JERSEY CENTRAL POWER & LIGHT COMPANY

OYSTER CREEK NUCLEAR GENERATING STATION

ECCS MODIFICATION

CORE SPRAY ELECTRICAL CROSSCONNECT

FIGURE 2-7
 MODIFICATION FOR MINIFLOW VALVES
 Revision 1 dated 7-15-75

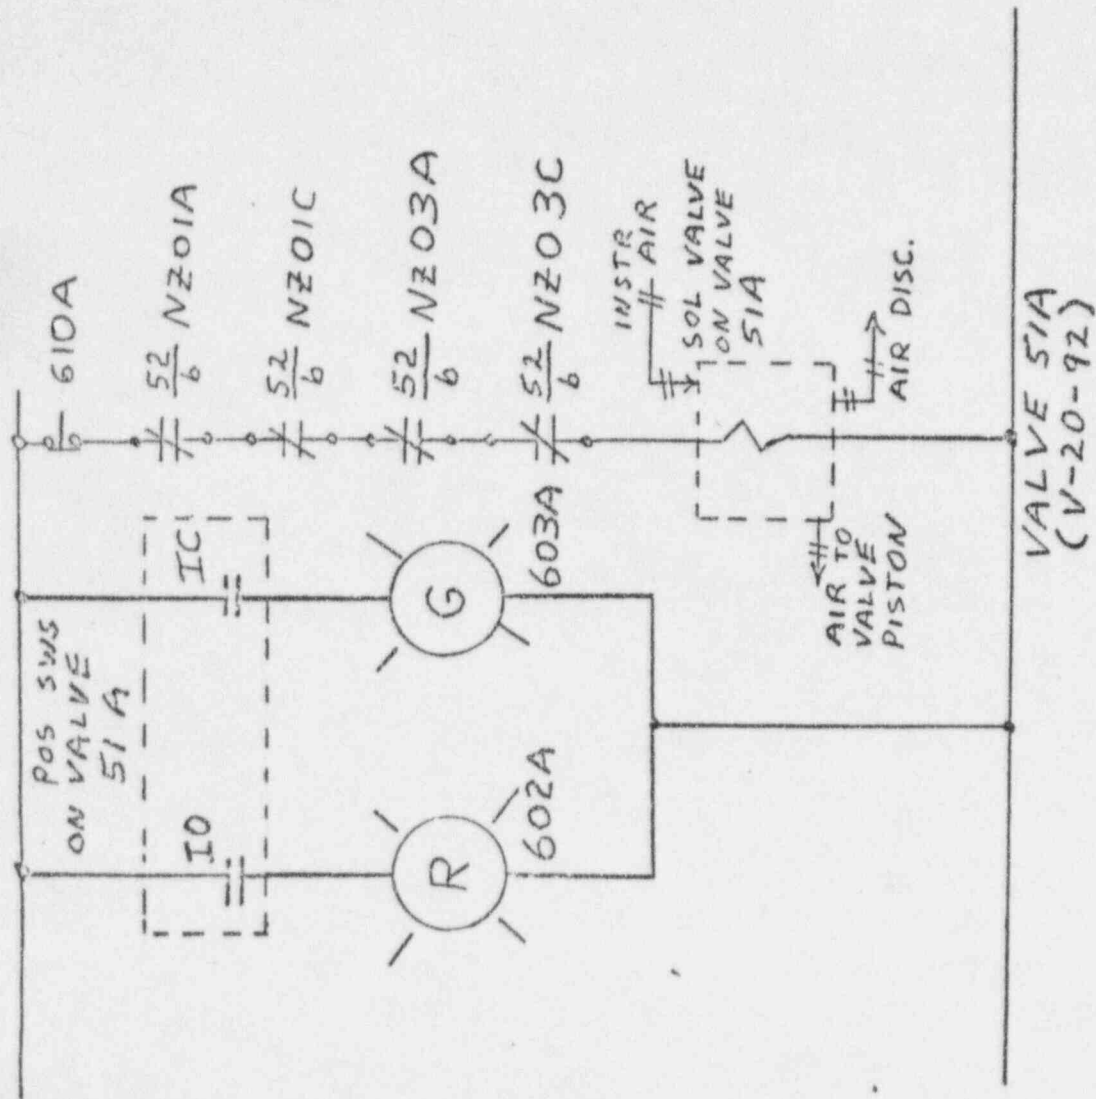
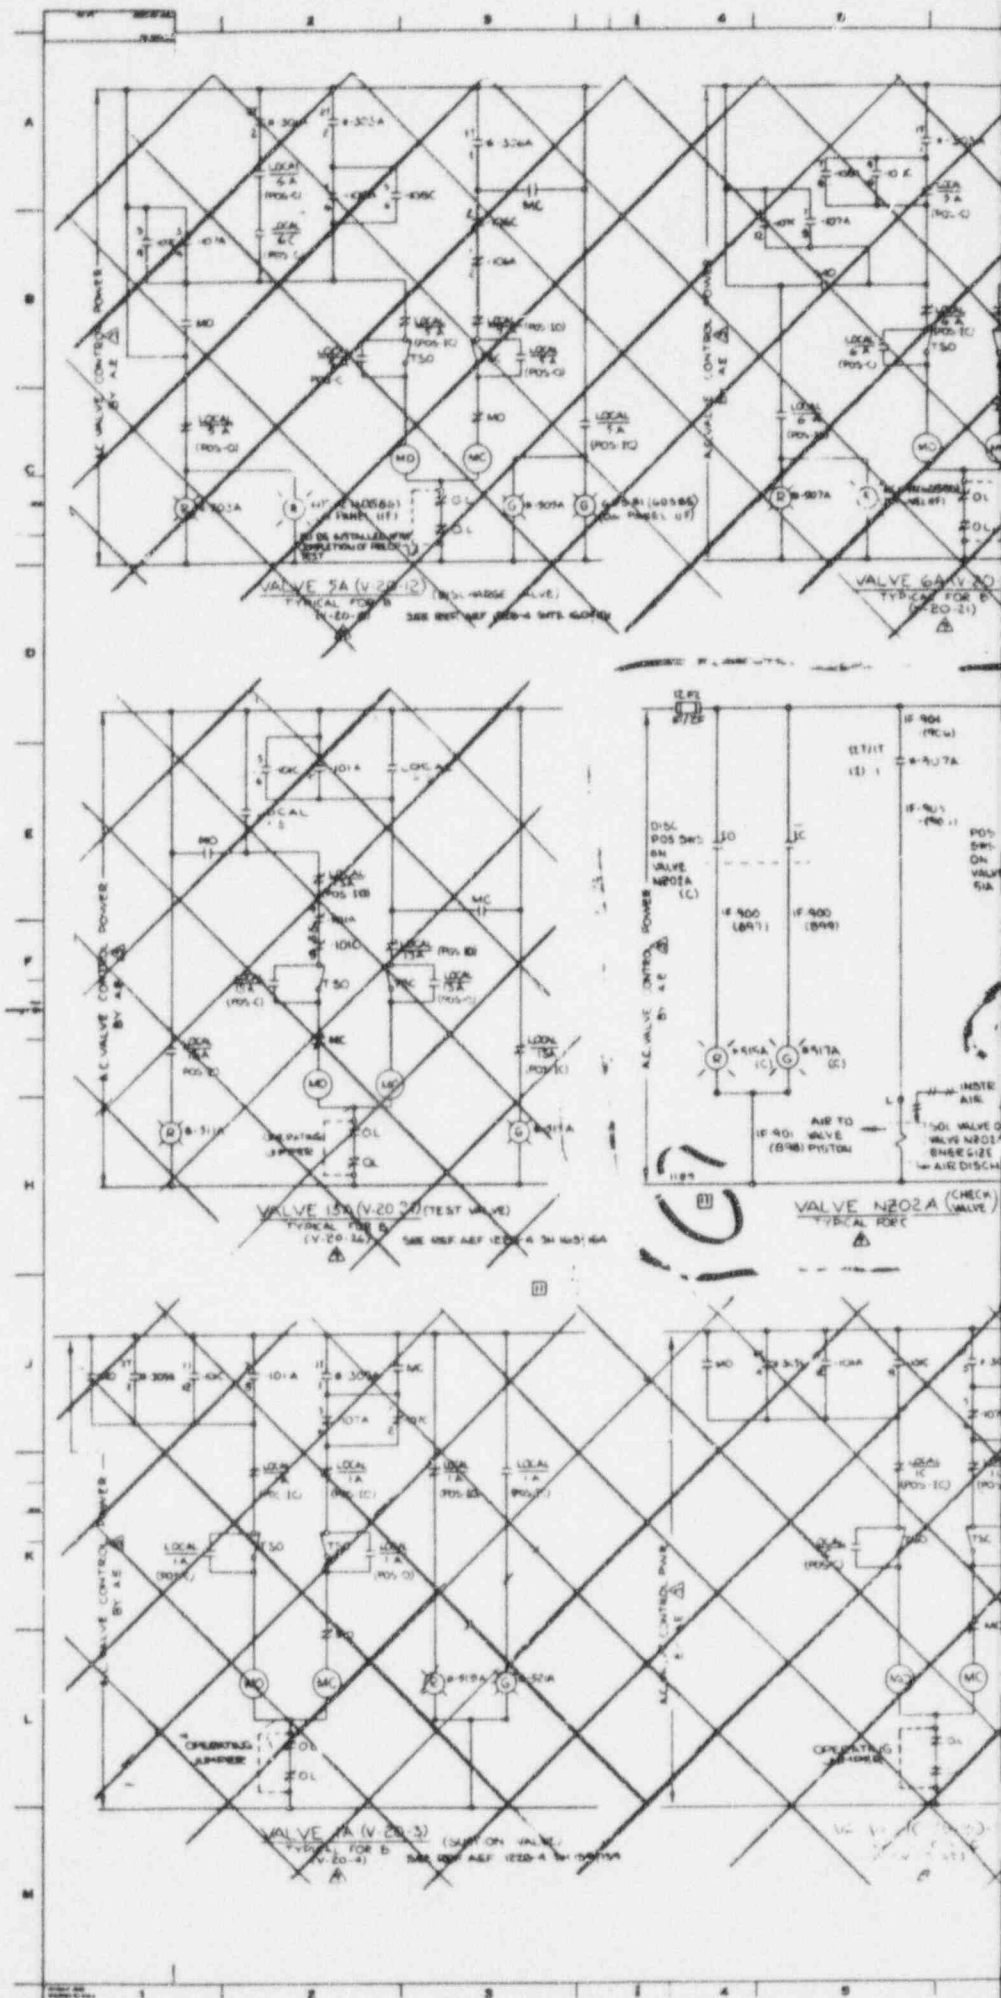
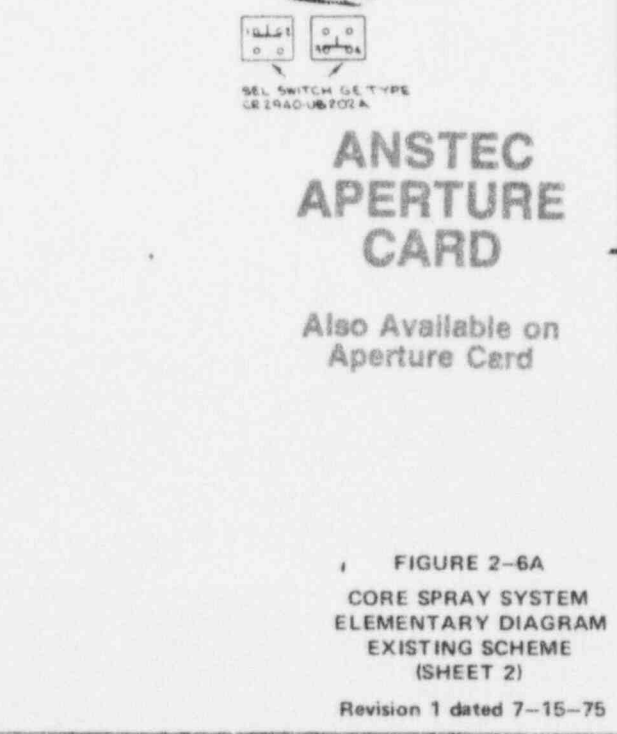
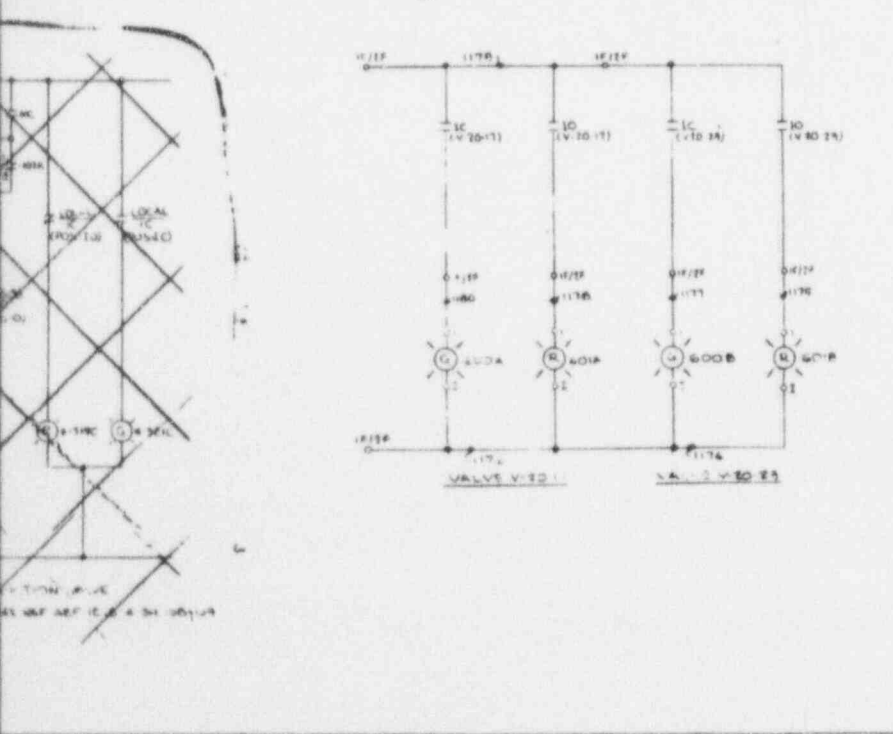
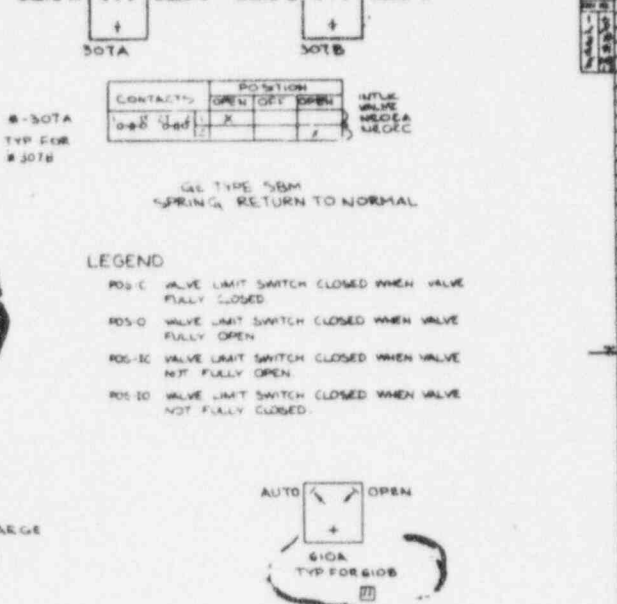
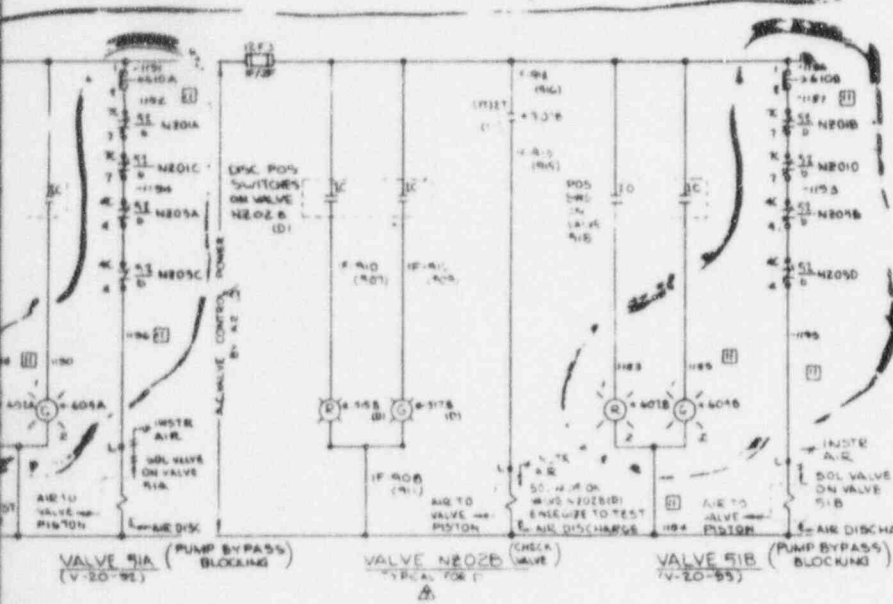
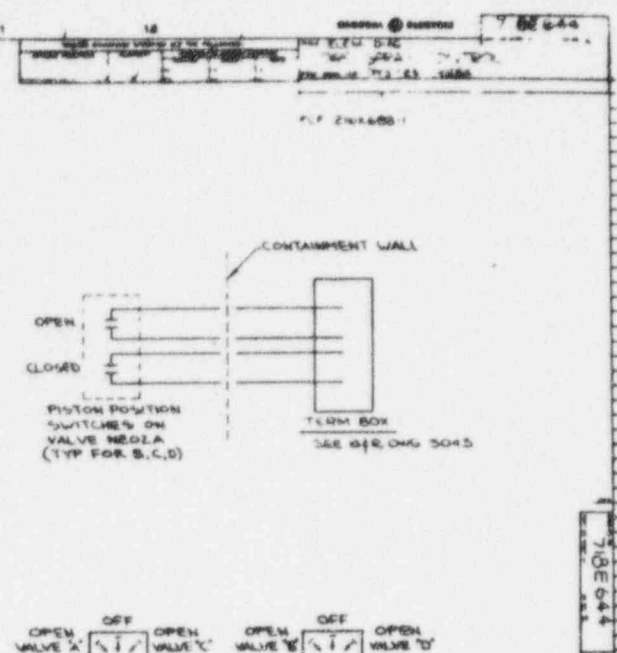
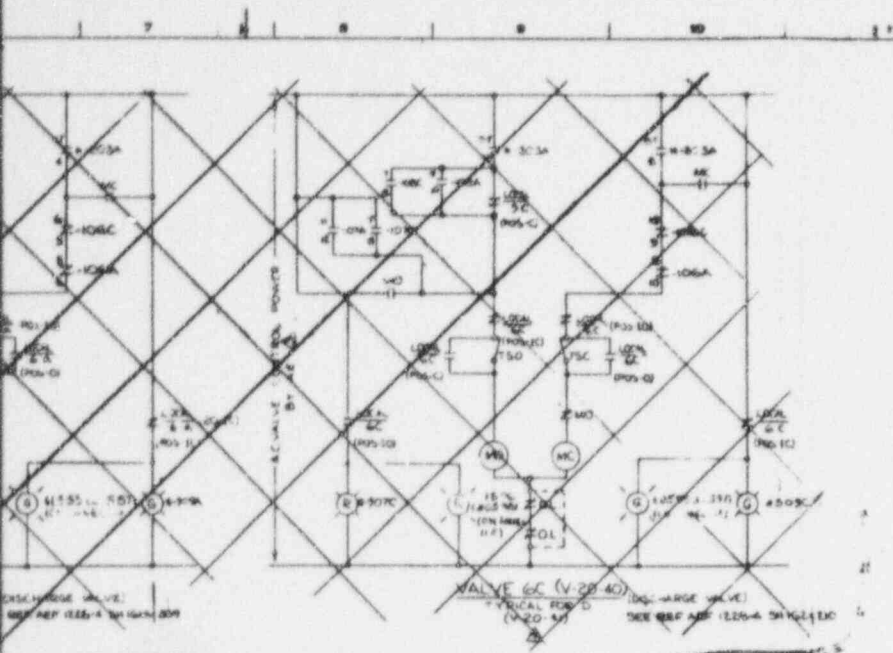
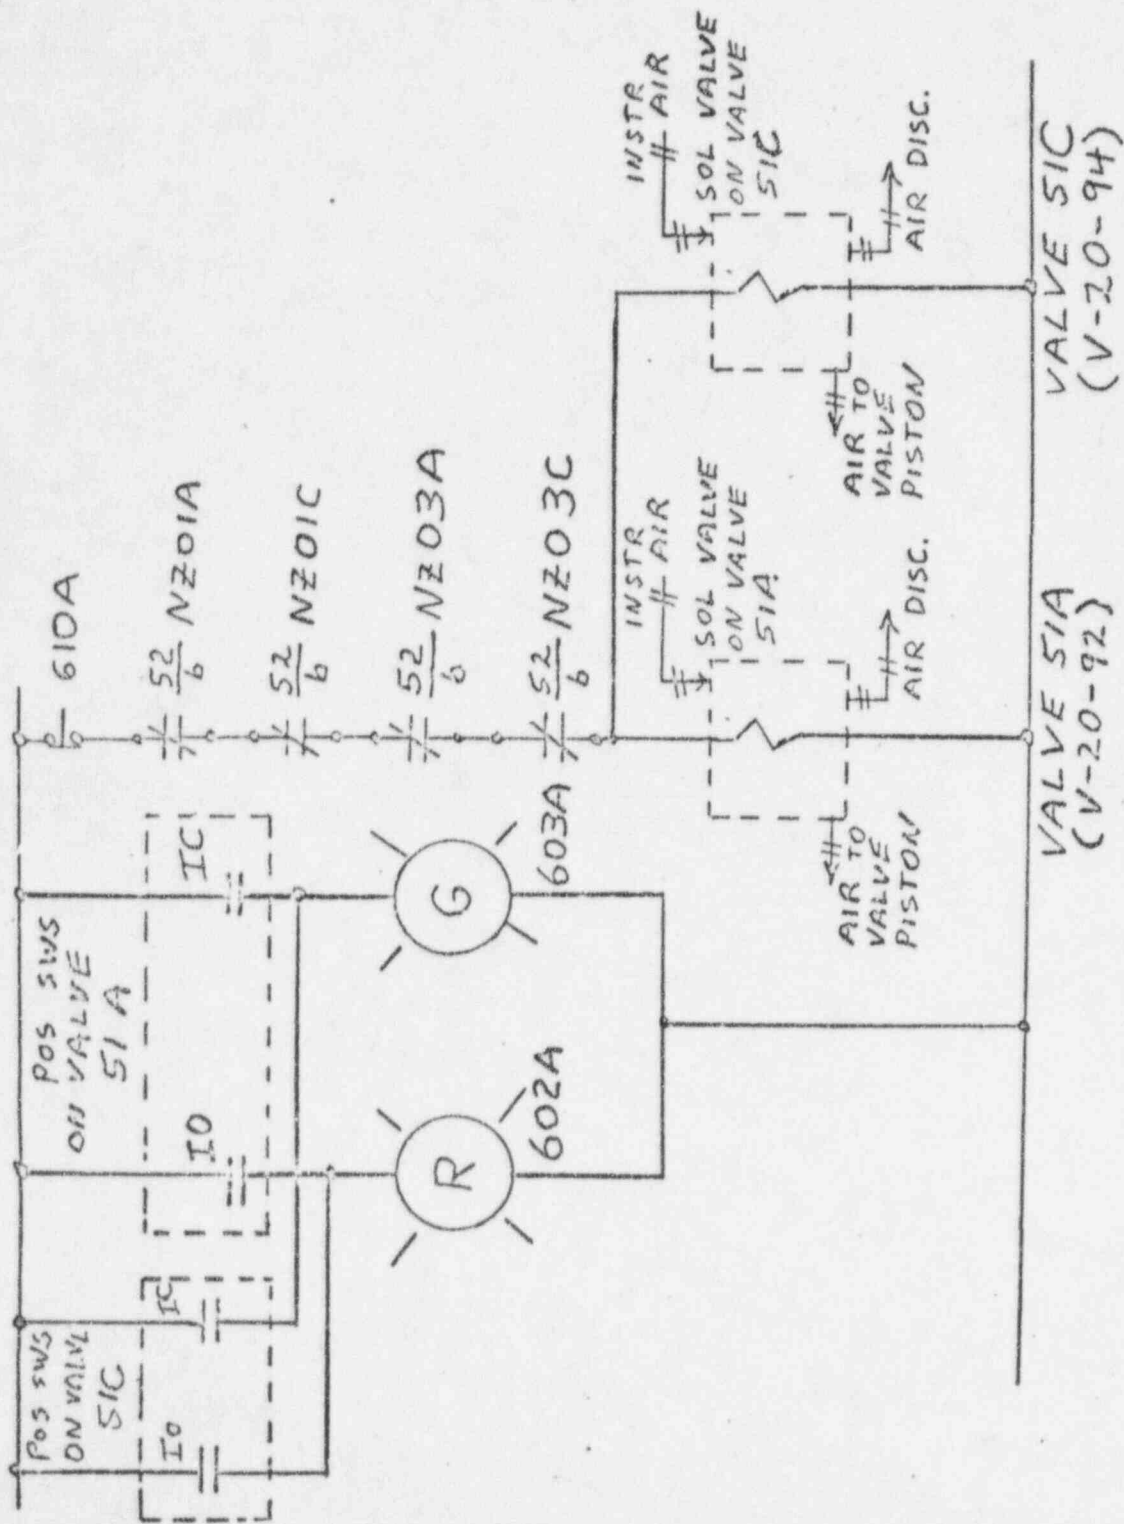
- o The installation of an additional booster pump minimum recirculation valve (V-20-94 for System I and V-20-95 for System II) in parallel with the existing valves. (See Attachment I, Item 806 and Attachment II, Item 806A and Figure 2-7.)

FIGURE 2-9
 OYSTER CREEK
 NUCLEAR GENERATING STATION
 REVISED
 D.C. ONE LINE DIAGRAM

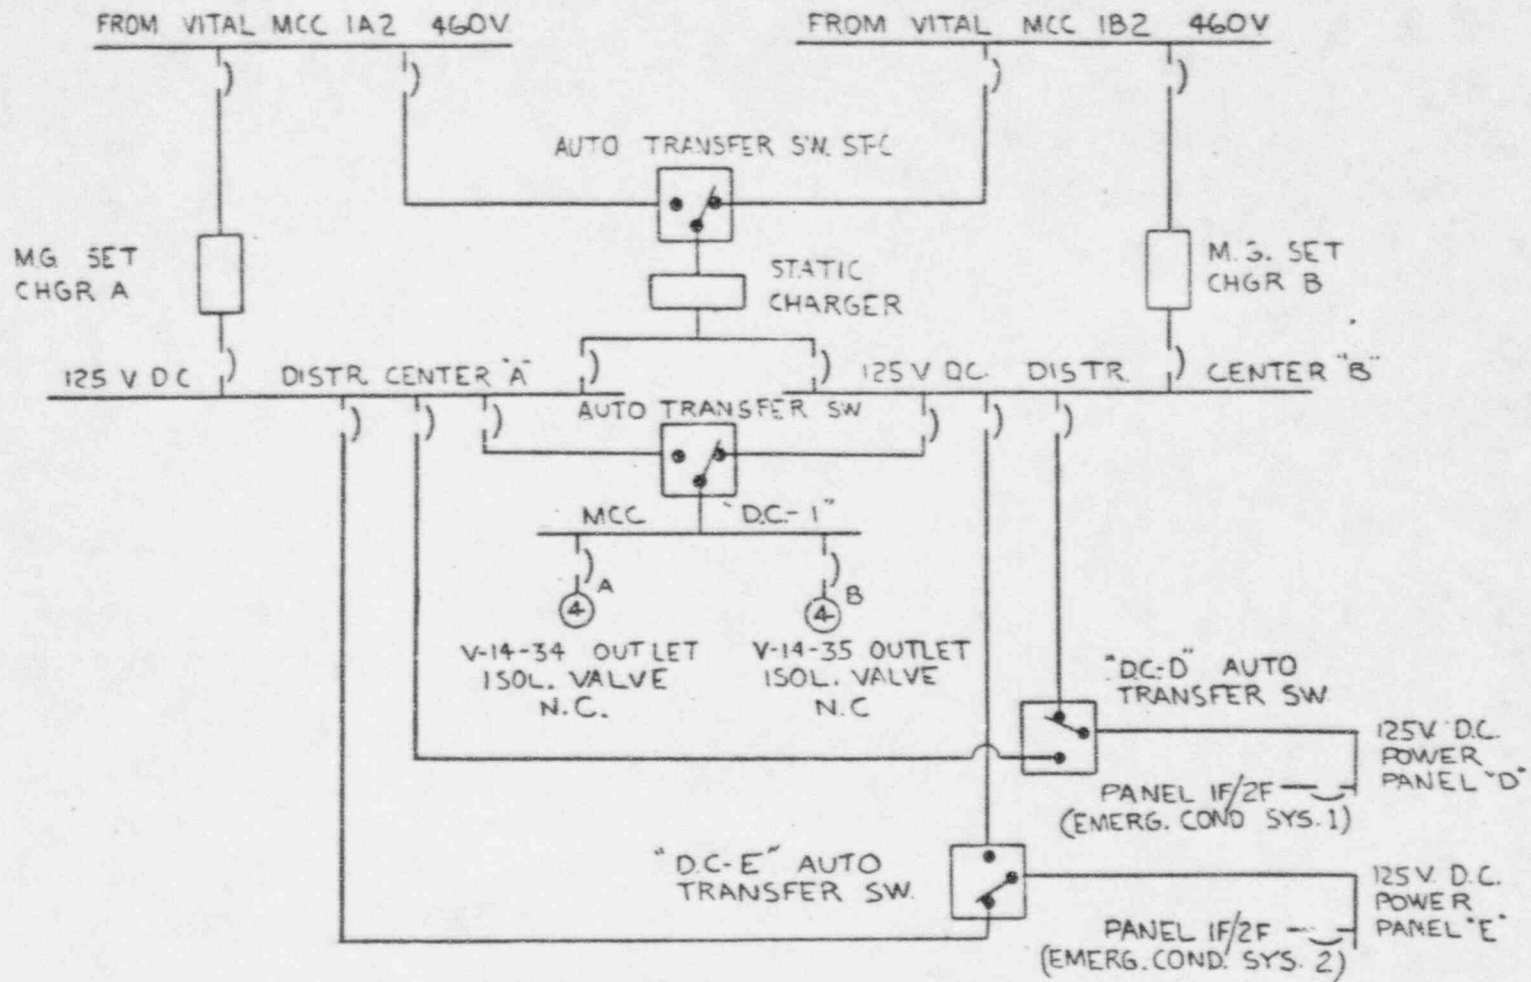
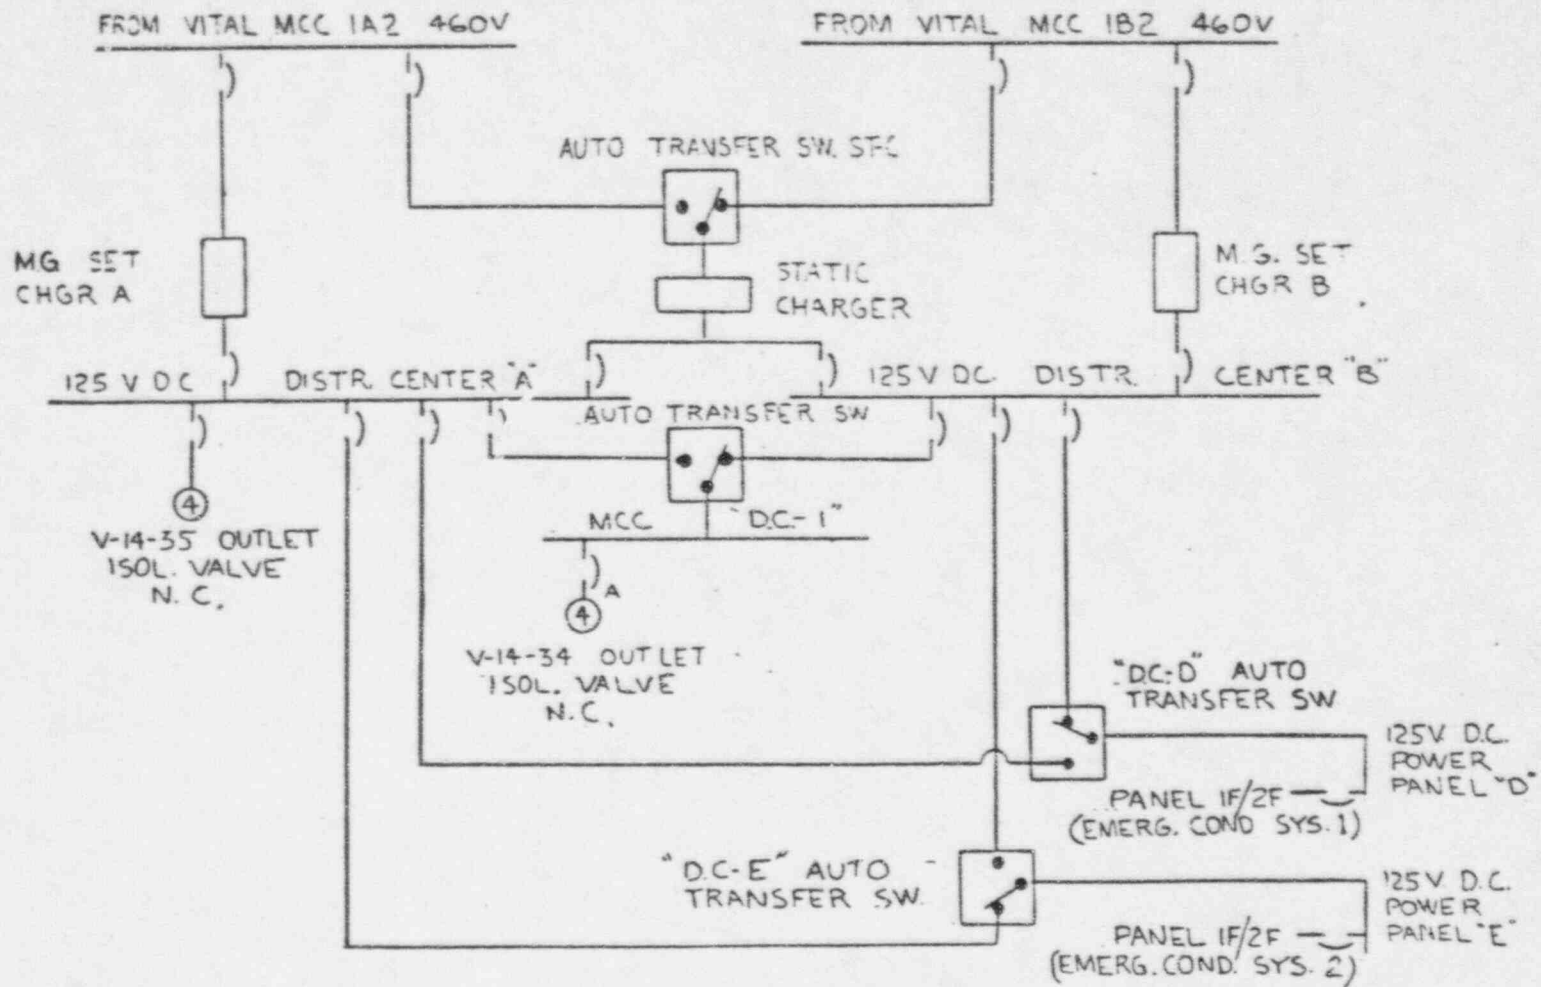
As identified in the Failure Mode and Effects Analysis (Table 2 of Attachment I, Items 211 and 212) a loss of power to motor control center DC-1 can prevent both emergency condenser isolation valves (V-14-34 and V-14-35) from operating. This will prevent both emergency condenser systems from initiating. Figure 2-8 shows the present configuration.

- o The modification will enable at least one system of the emergency condensers to operate in the event of a loss of power to motor control center DC-1. The modification consists of disconnecting the motor operator of emergency condenser isolation valve V-14-35 from MCC-DC1 and connecting it to a separate motor starter whose power source will be the 125 VDC distribution center A as shown on Figure 2-9. Table 5 of Attachment II is the Failure Mode and Effects Analysis for this modification.
